2023 Castrol Toyota Formula Regional Oceania Championship Technical Amendment

Championship Amendment

1. Amend Article 10.1.1 – Front Suspension as stated in the schedule below.

1. 10.1.1 Front Suspension

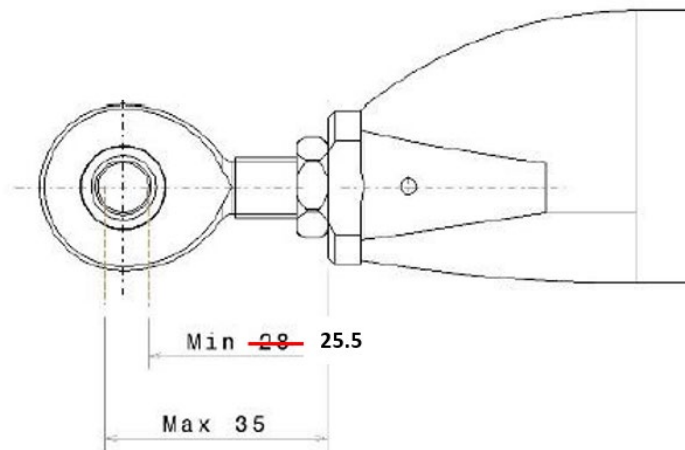
The caster of the front suspension must be set respecting the measurement defined by diagram below.

For clarification, Min & Max are defined from the centre of the spherical bearing.

Reason: To allow for the reduction of caster, and to clarify the caster measuring points.
